1207 PLOT 9B FIRST STREET, MANCHESTER

NMA APPLICATION REPORT

1207-TGA-XX-XX-RP-A-FI_10_10-00400 P01

TIM GROOM ARCHITECTS

Unitised Facade - Initial Revised Proposal

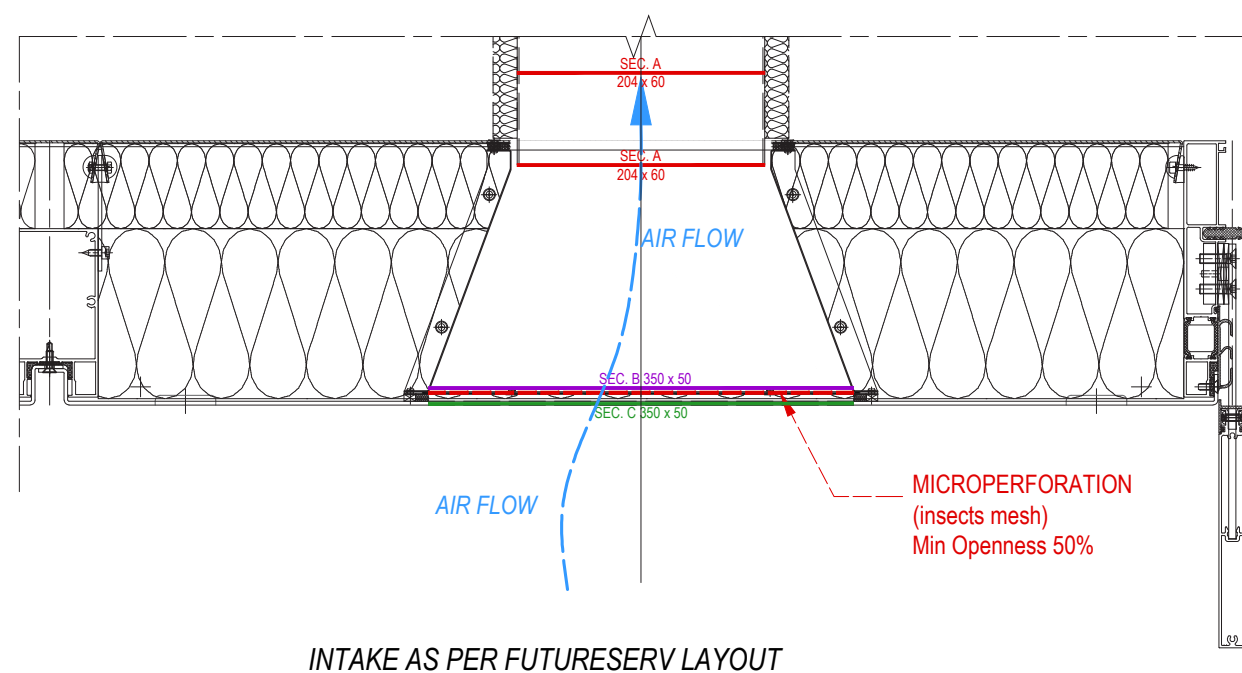
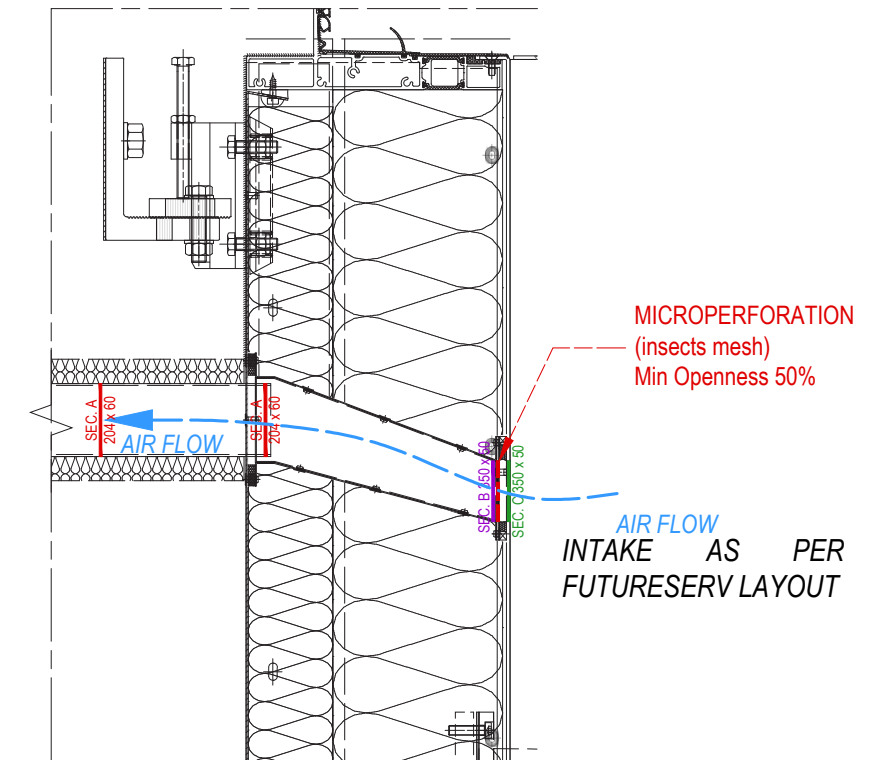
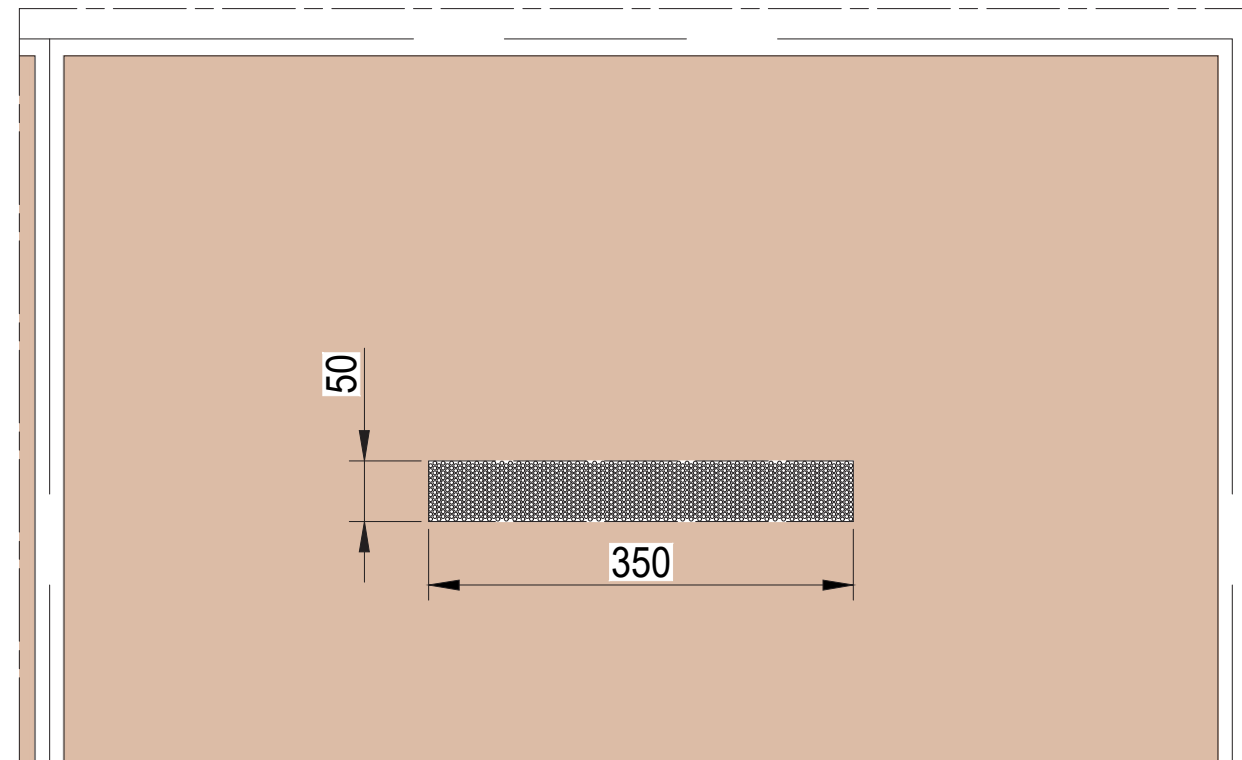
The drawings opposite illustrate the initial revised proposal from the facade specialist for an additional vent opening within the facade.

The additional vent was proposed as a punched letterbox opening within the facade panel.

The design team felt that the proposal was unacceptable on the basis that the vent was not sufficiently integrated within the facade design.

Unitised Facade - Refined Revised Proposal

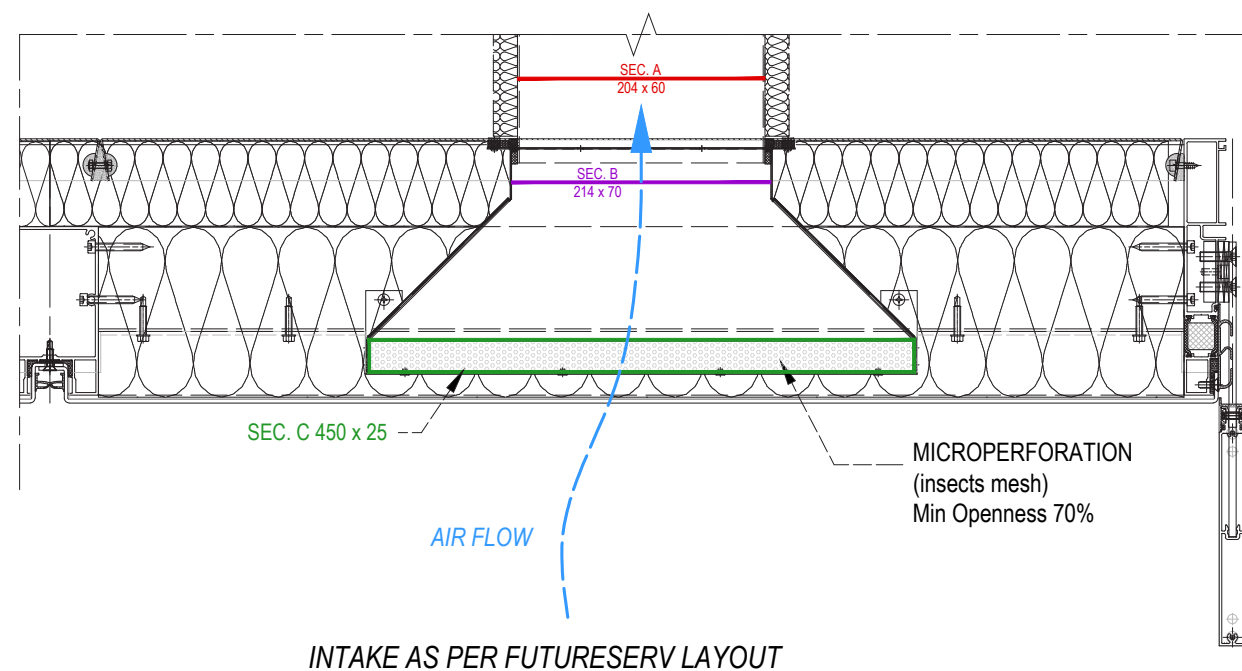
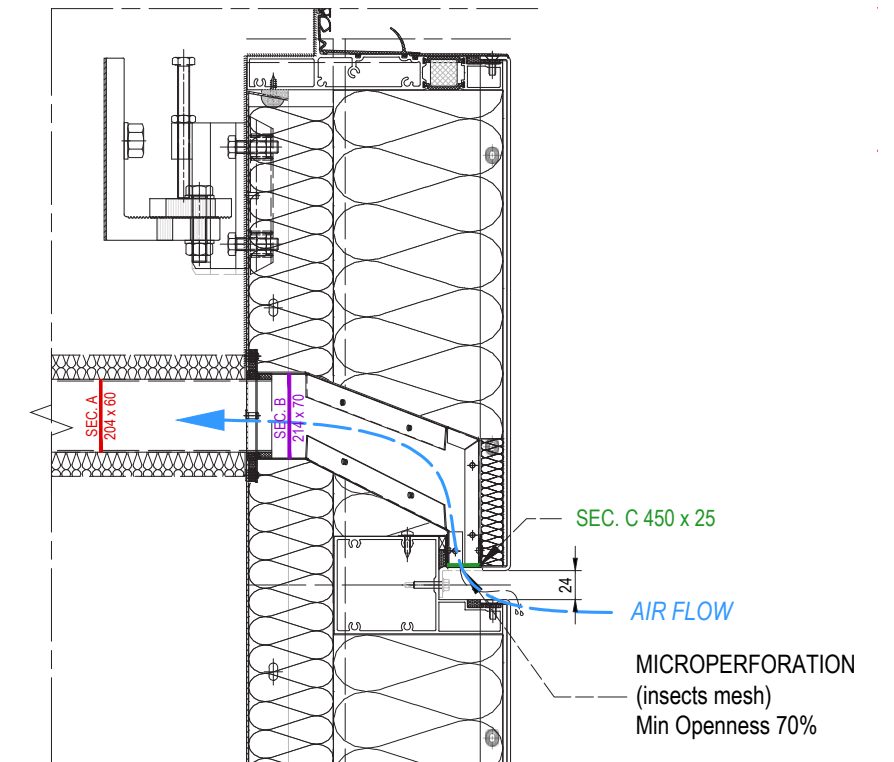
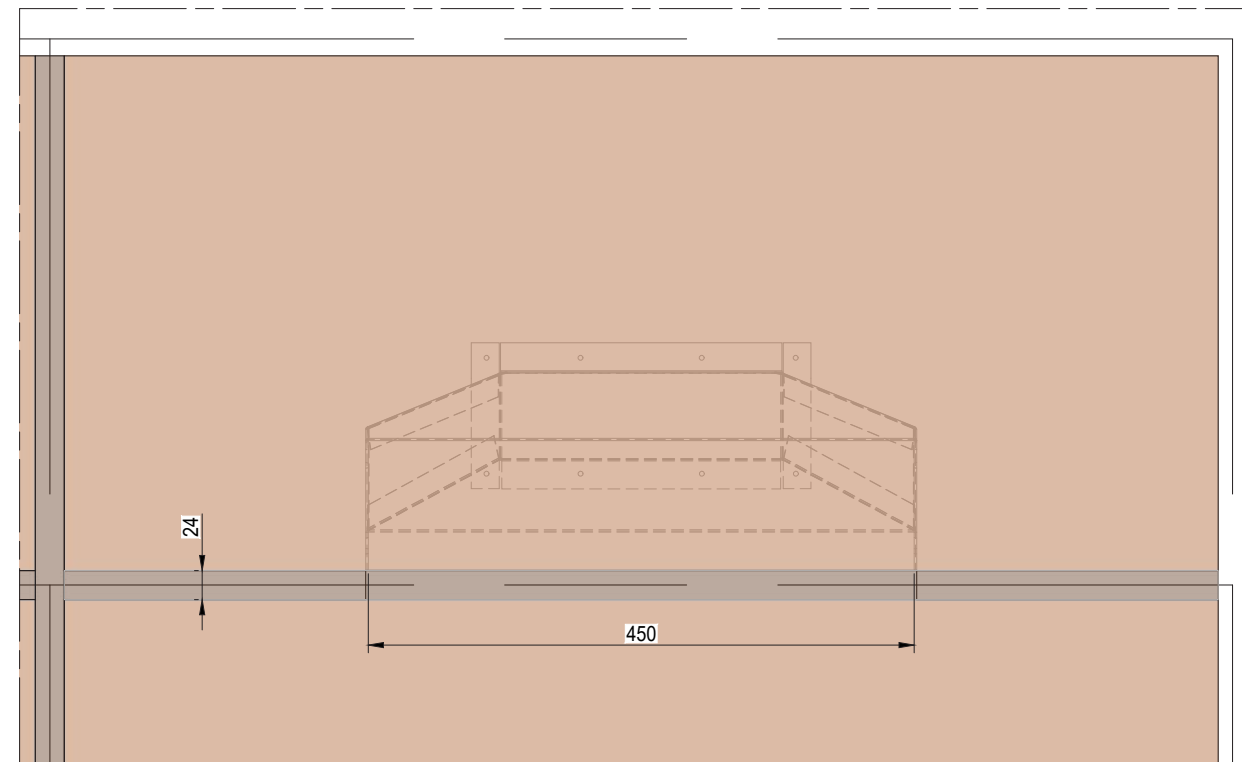
Following scrutiny from the design team, the facade specialist revisited the integration of the required additional vent within the facade system.

The revised proposal successfully integrates the required vent into a 24mm high slot which mimics the existing joints within the facade panels.

An additional visible joint line is required at every level to accommodate the slot vent.

The height at which the vent is located within the facade is restricted by functional requirements. As a result, the existing joint banding is required to drop in level.

The banding between windows at every other level has to remain at the current height to avoid a clash with the vent to the decorative panel.

Ventilation Strategy
Unitised Facade - Refined Revised Proposal

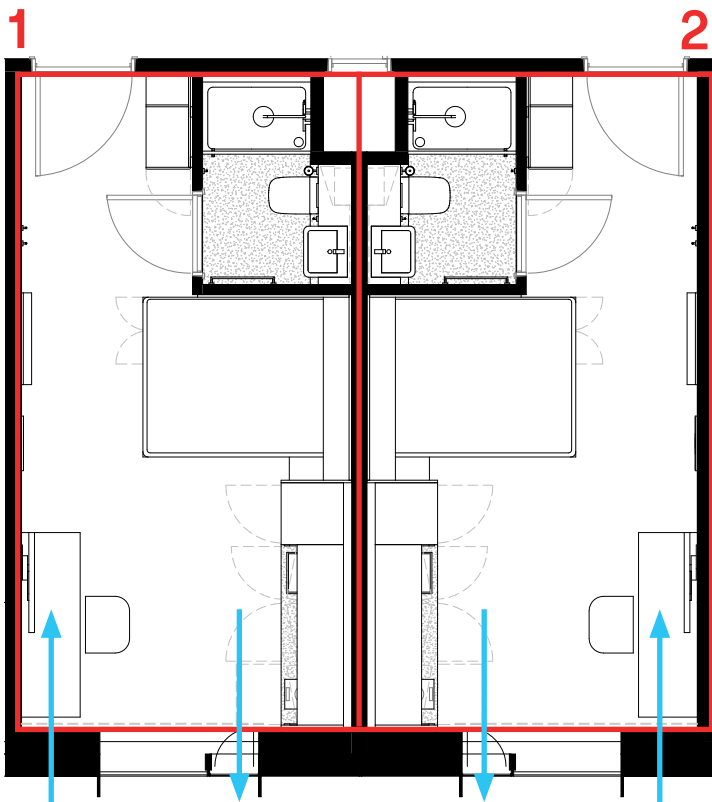
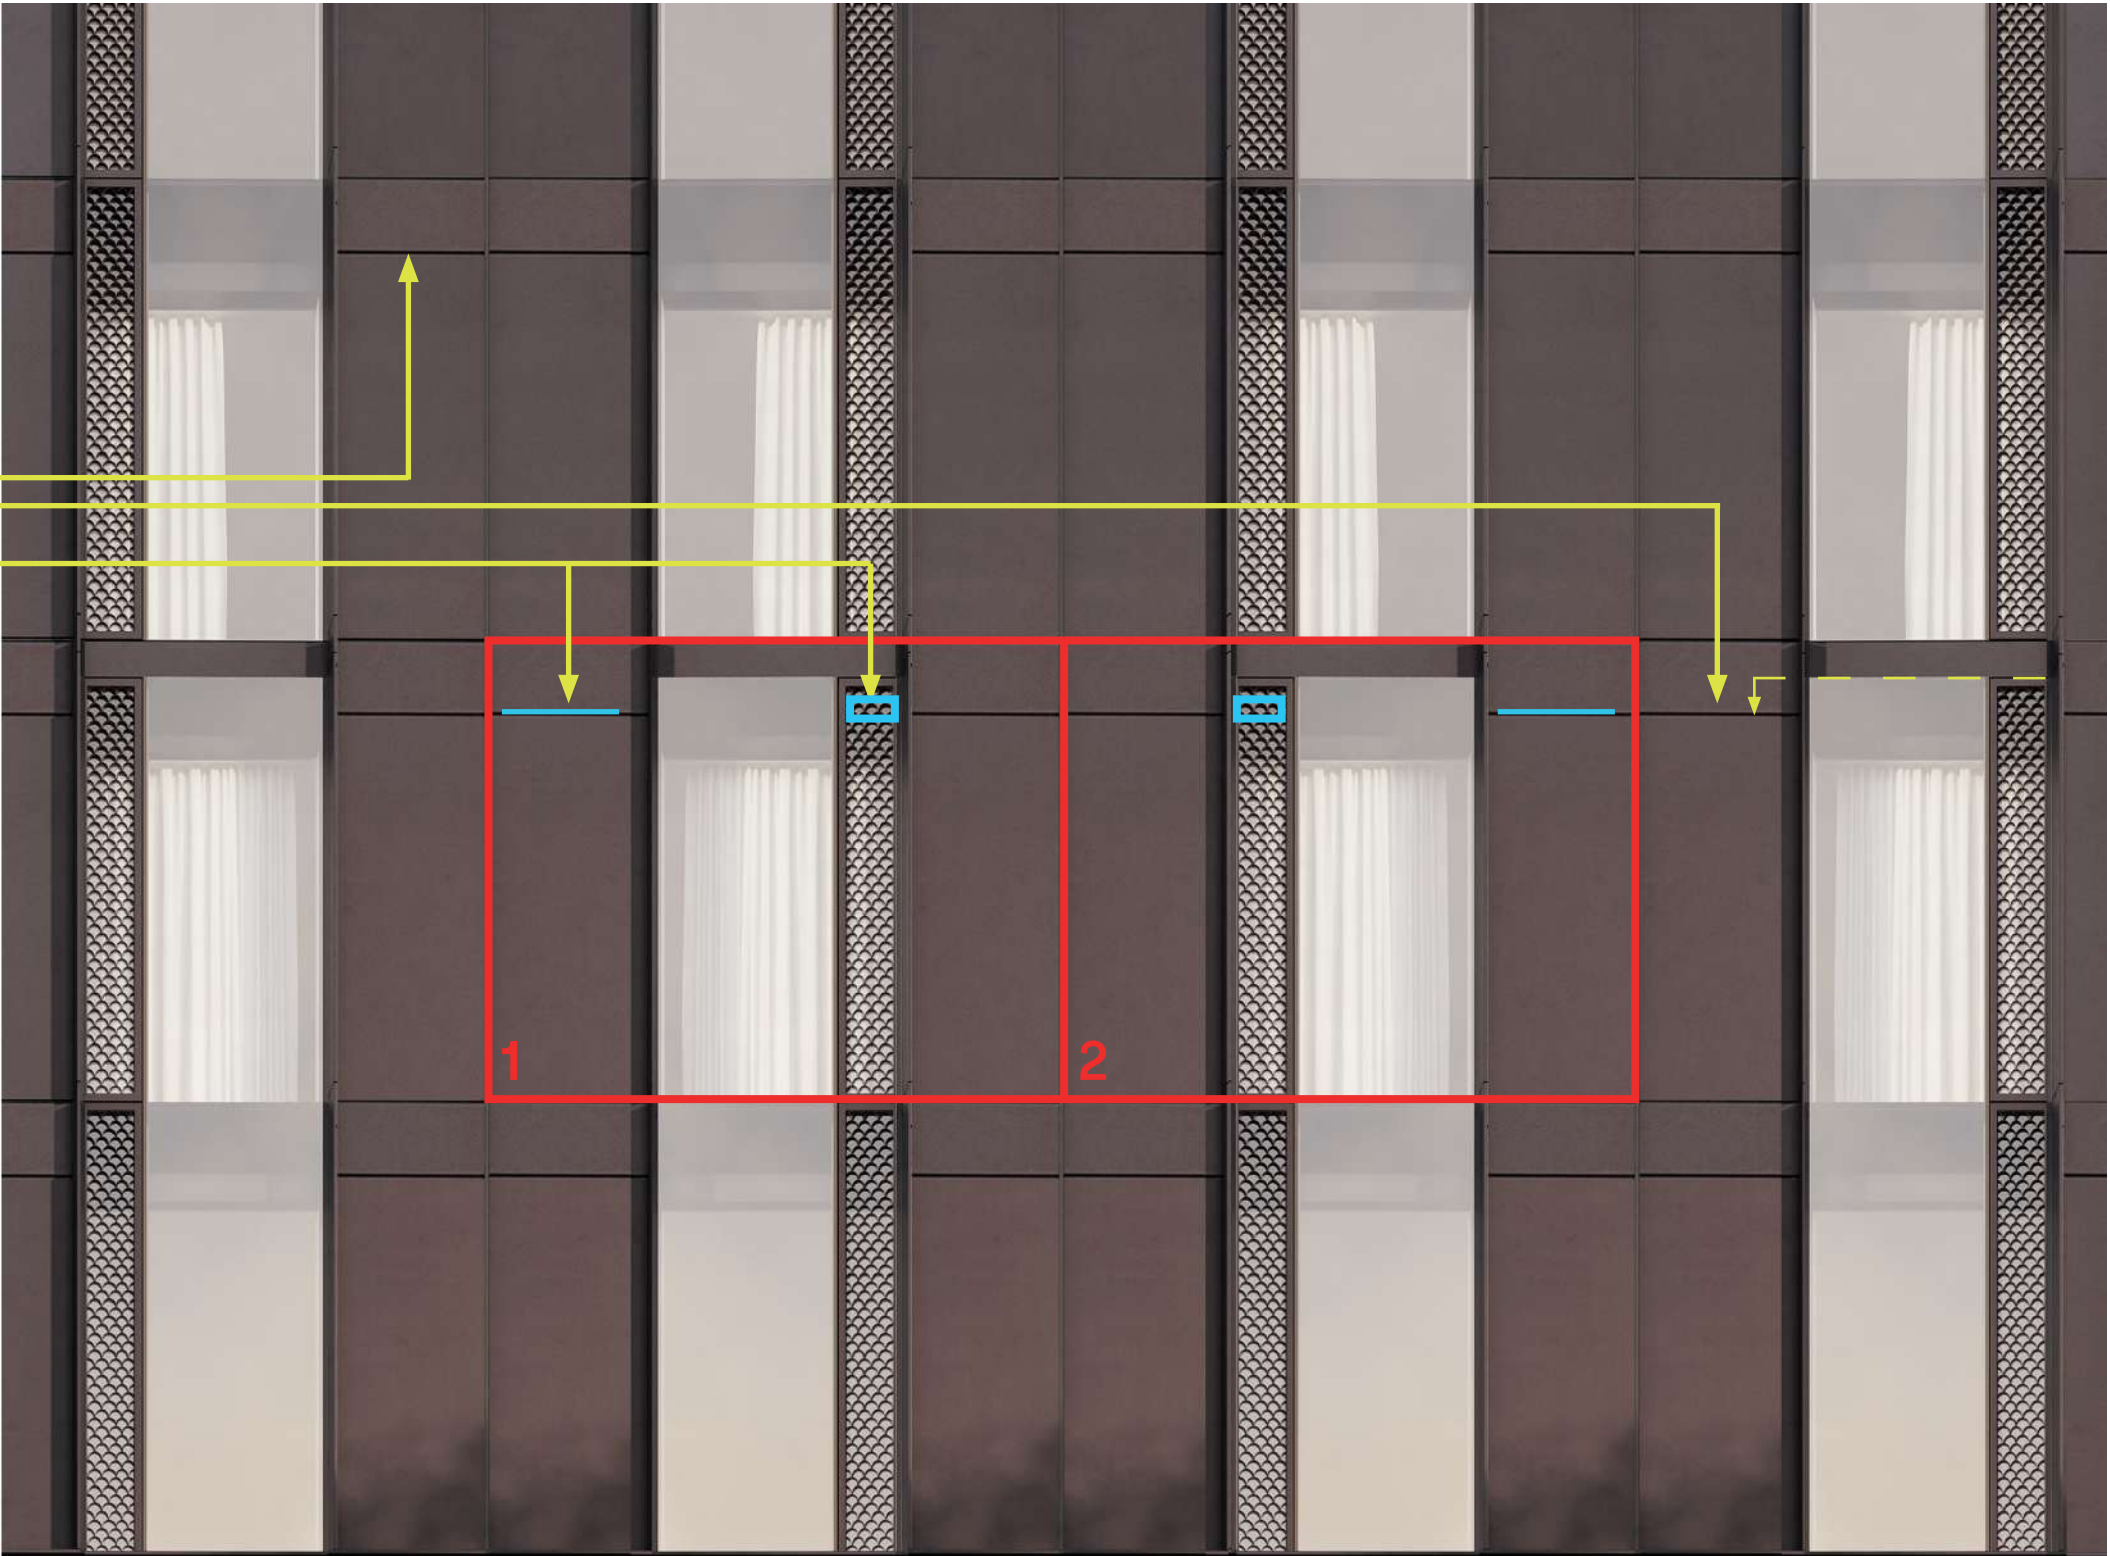
The Plan Diagram below illustrates the revised ventilation strategy for the single studios. An Inlet and Extract is required to each individual studio.

The Elevation render opposite provides the visual impact of the revised ventilation proposal on the facade based on the refined proposal.

The proposal drops the banding at every second floor and introduces a further joint band at the other intermediate levels.
